Well Name: BOLL WEEVIL 27-34 FED COM	Well Location: T26S / R34E / SEC 27 / NWNE / 32.021 / -103.455	County or Parish/State: LEA / NM
Well Number: 10H	Type of Well: OIL WELL	Allottee or Tribe Name:
Lease Number: NMNM100569	Unit or CA Name:	Unit or CA Number:
US Well Number: 3002547957	Well Status: Approved Application for Permit to Drill	Operator: DEVON ENERGY PRODUCTION COMPANY LP

Notice of Intent

Type of Submission: Notice of Intent	Type of Action: APD Change
Date Sundry Submitted: 11/17/2023	Time Sundry Submitted: 08:09
Date proposed operation will begin: 11/17/2023

Procedure Description: Devon Energy Production Company L.P. respectfully requests the following changes to the approved APD: BHL change from 20 FSL & 1305 FEL to 20 FSL & 1440 FEL, both 34-26S-34E Dedicated acreage change from 471.68 acs to 235.87 acs. Pooling Order in process. TVD/MD change from 12800'/20277' to 12850'/20269' Casing program change: Surface, Intermediate, and Production Casing size changes. Cement volume changes to accommodate casing change. Please see attached revised C-102 and drilling & directional plans and other supporting documentation.

WELL LOCATION AND ACREAGE DEDICATION PLAT

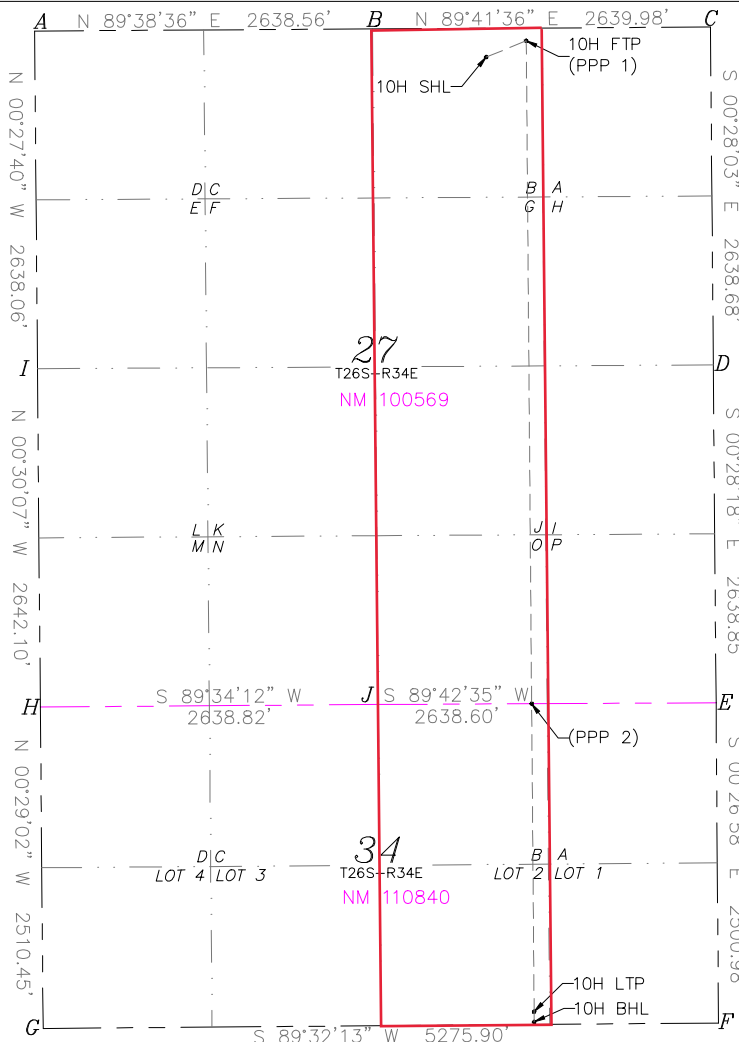
UL or lot No.	Section	Township	Range	Lot Idn	Feet from the	North/South line	Feet from the	East/West line	County
2	34	26-S	34-E		20	SOUTH	1440	EAST	LEA

Dedicated Acres	Joint or Infill	Consolidation Code	Order No.
235.87			Pooling Order in process

Well: BOLL WEEVIL 27-34 FED COM 10H
County: Lea
Wellbore: Permit Plan
Design: Permit Plan #1

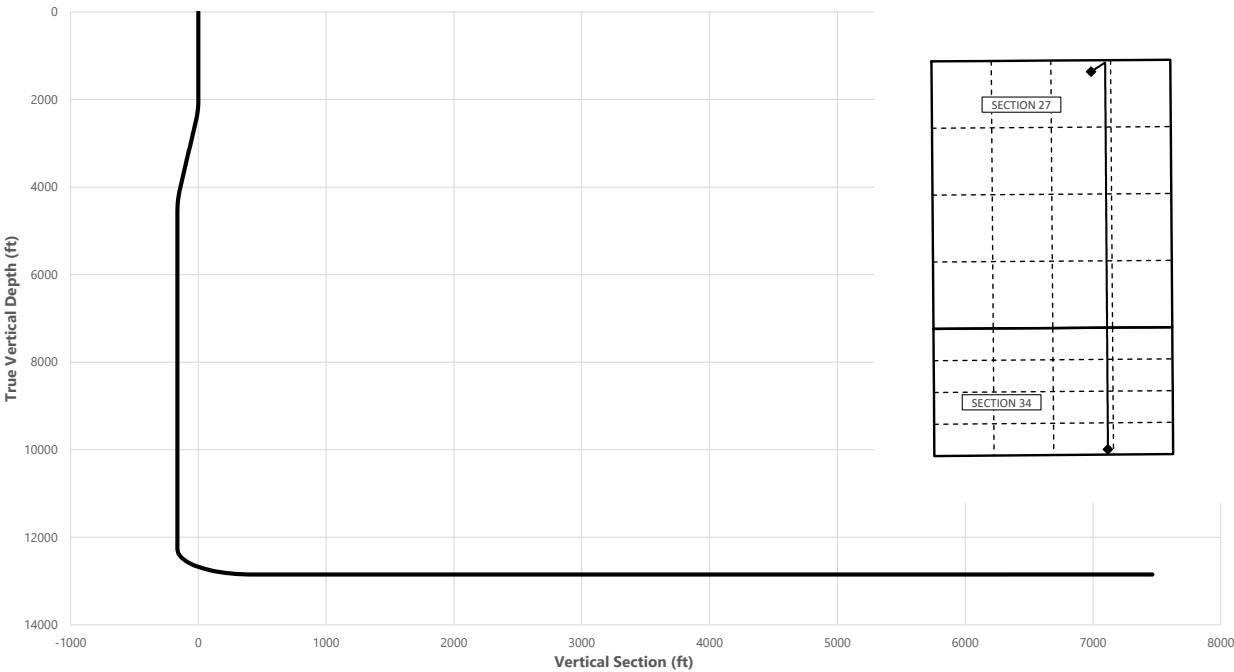
TVD/MD change from 12800/20277 to 12850/20269'
